Capital School District
Central Middle School
Interior Renovations
211 Delaware Ave. Dover Delaware 19901
Bid Pac E— Contracts 1 thru 10
October 7, 2024

Addendum No. 1

PROJECT: Central Middle to Elementary School Interior Renovation

PROJECT NO: 2021101.00

DIMENSIONS ARE TO EXTERIOR FACE OF CONCRETE, MASONRY, OR

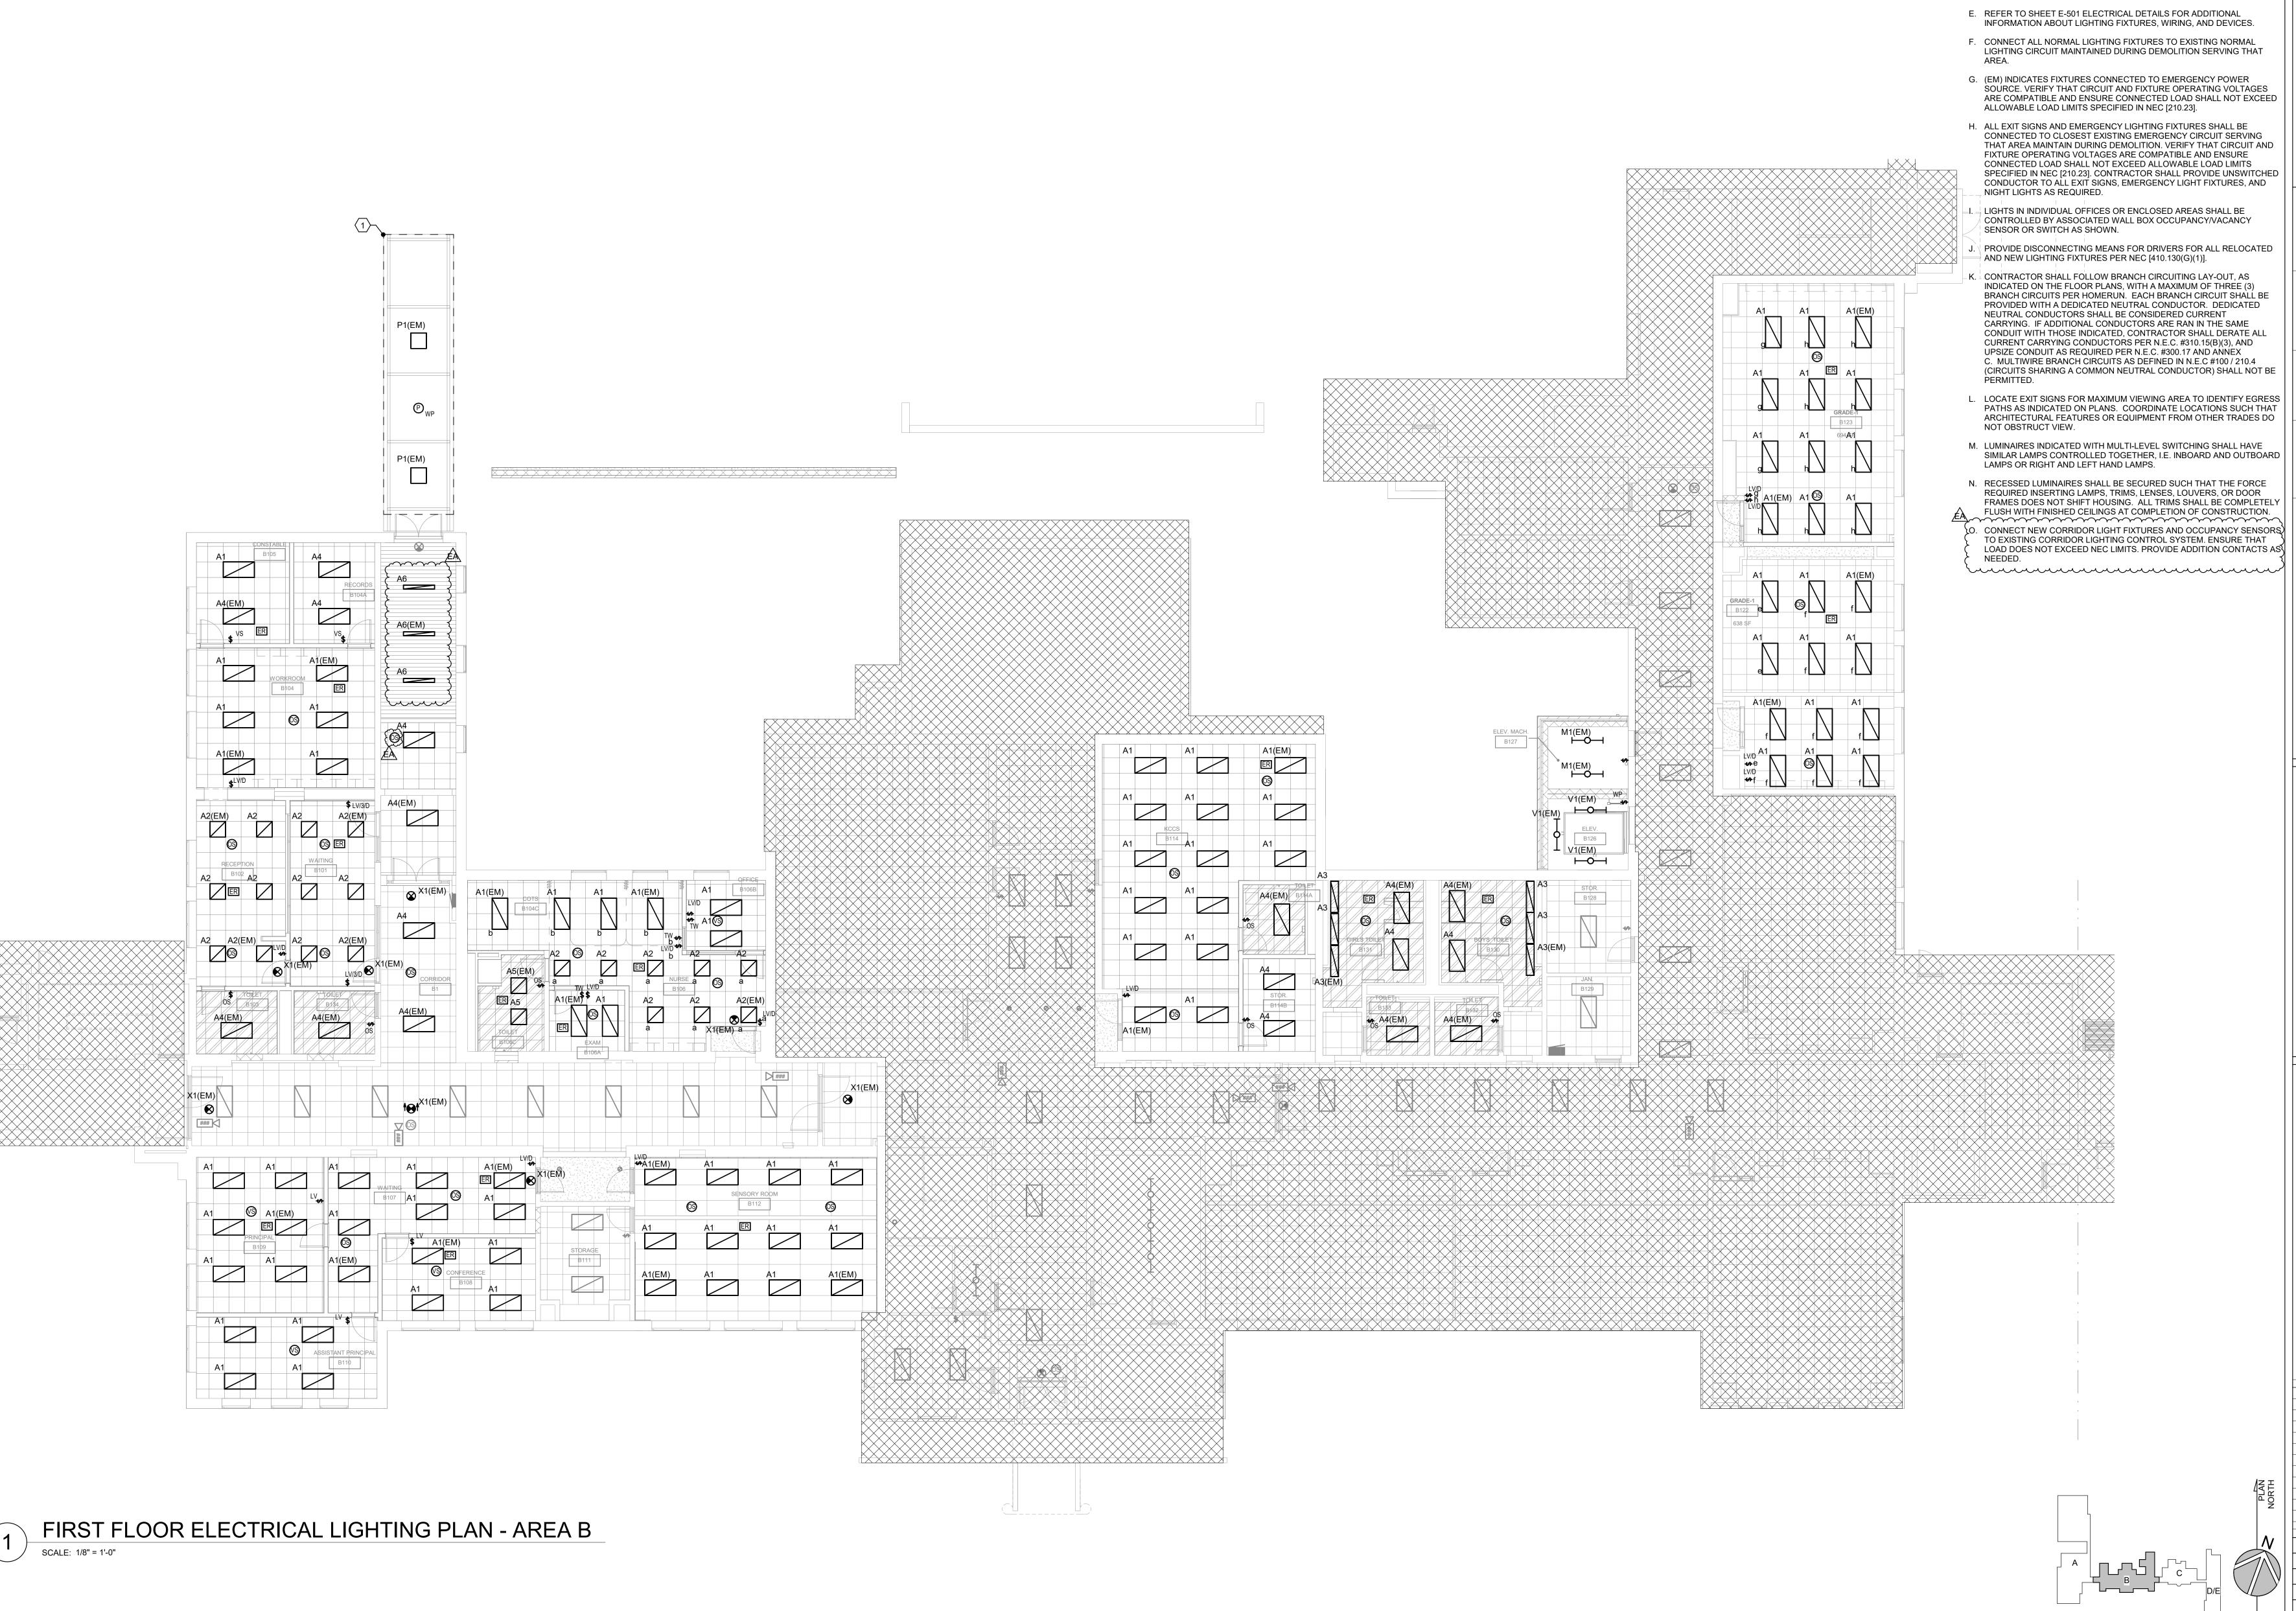
- 2. A101D-E FIRST FLOOR PLAN AREA D/E
 - a. Detail 1:
 - i. **ADD** exam curtains (3) in nurse's suite.
- 3. A106-E FIRST FLOOR FINISH PLAN AREAS B, D/E (BASE BID)

E-201B

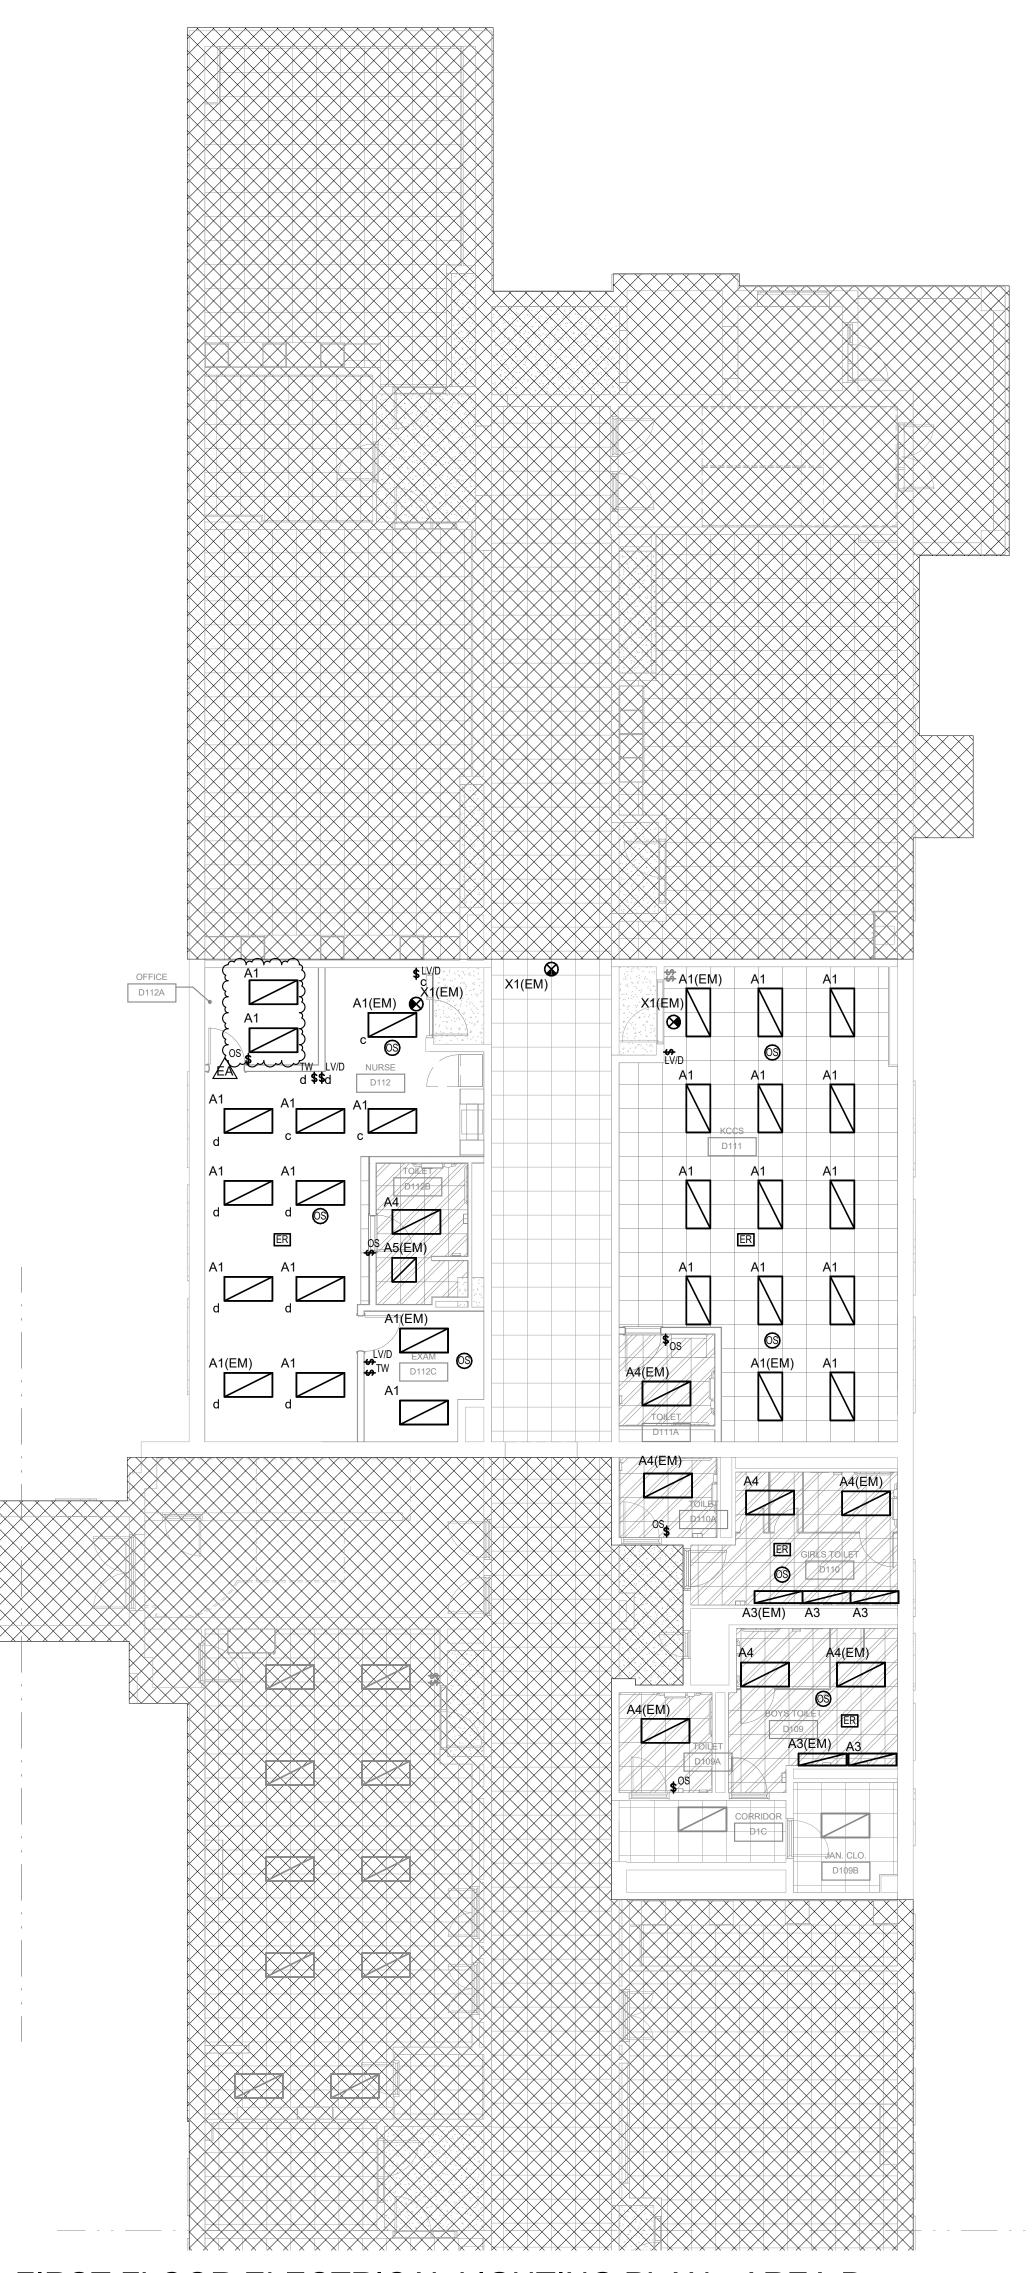
- 5. ED-101B FIRST FLOOR ELECTRICAL DEMOLITION PLAN AREA B
 - a. ADD demolished lights in corridor B151.
- 6. E-201B FIRST FLOOR ELECTRICAL LIGHTING PLAN AREA B

- a. ADD two (2) A6 light fixtures and one (1) A6(EM) light fixture in corridor B1.
 - b. **ADD** occupancy sensor in corridor B1.
 - c. ADD general note O.
